## Access Compliance Report Public Rights-of-Way (Curb Ramps)

Intersection ID: 6829Main Street:PRINCESS\_STCross Street:W\_SUGAR\_CREEK\_RDLocation:WADA ID: 1C99FCE69736Ramp Type:Combination1Initial Pass/Fail:FailOverall Compliance:NoSeverity Score:10

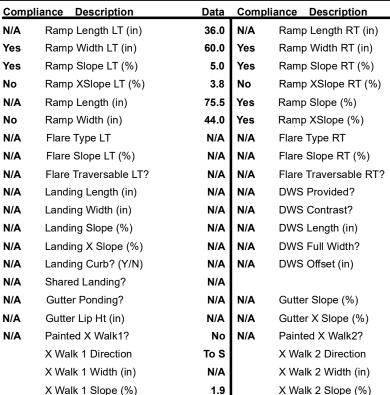
GTR GAP 2.0, RT RP < 5%

Not Found, R304.5.1, R304.5.3

Remove & Replace Entire Ramp.
